AGENDA
CITY OF STURGEON BAY
AESTHETIC DESIGN & SITE PLAN REVIEW BOARD
Monday, October 26, 2020
6:00 p.m.
Council Chambers, City Hall
421 Michigan Street, Sturgeon Bay, WI

To: Aesthetic Design and Site Plan Review Board
From: Christopher Sullivan-Robinson
Date: October 22, 2020
Subject: Third Avenue Play House Façade Improvements

Building Facade Restoration

TAP STREET ELEVATION
1/4" = 1'-0"

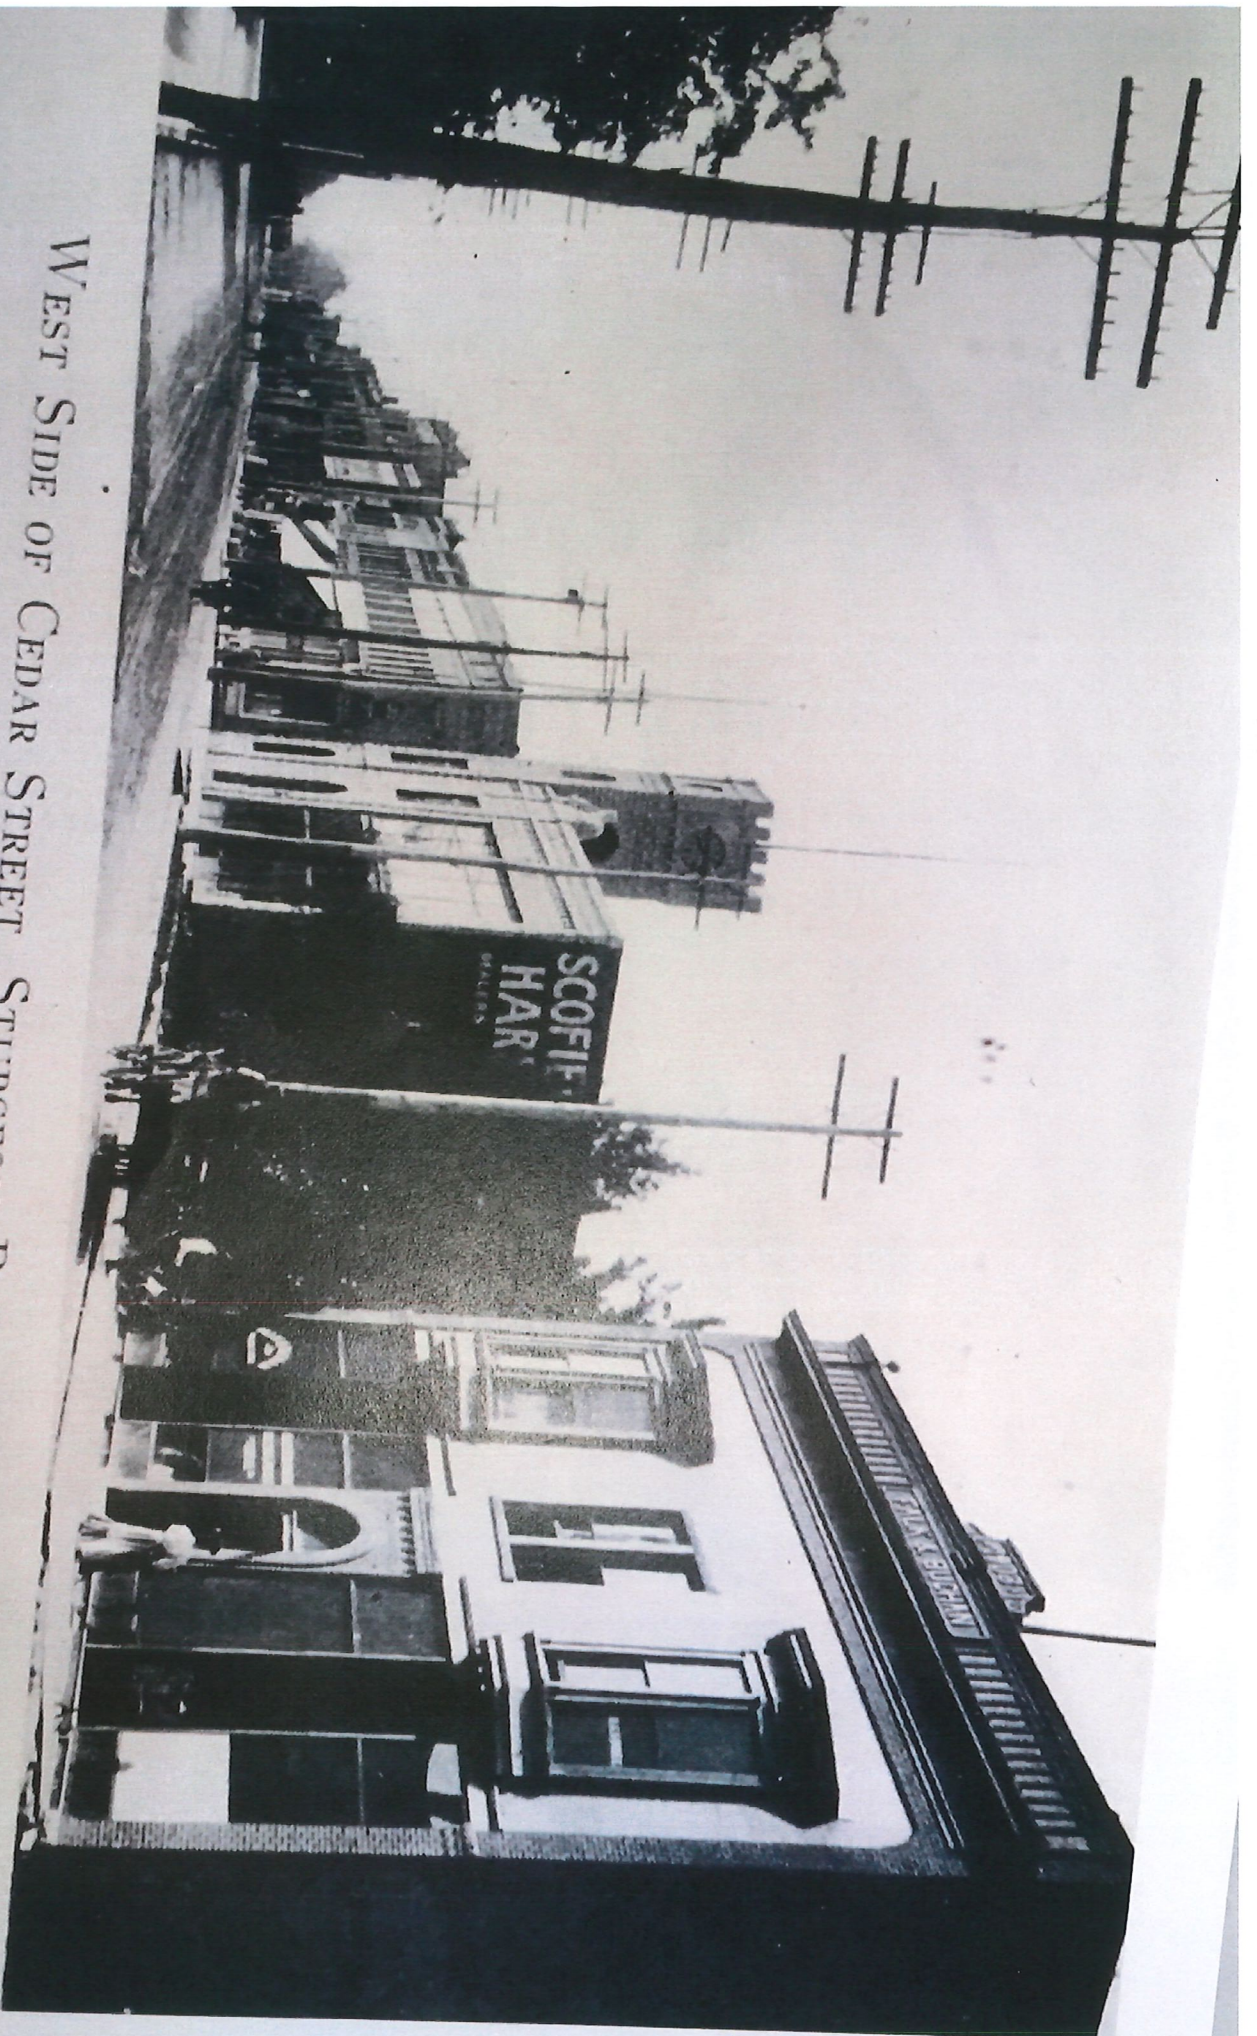
The architectural style and materials match other buildings in the downtown historic district and is generally common for this area. Based on the images provided, the proposal restores the building more toward its original construction style.

There are no changes in the building's location and the design is complimentary to the area and streetscape.

The building is not located within the city designated historic district. However, the proposed design enhances the general look of the building by providing spacing between the

windows, decorative cornices, and more windows on the street frontage. This is consistent with the historic district's design strategies.

The existing building is significantly taller than the adjacent buildings.

There are no canopies or awnings proposed.

There are no structural alterations proposed.

There is no parapet proposed.

The street façade of the building will be refaced with brick.

No metal is proposed for the building façade that faces the right-of-way.
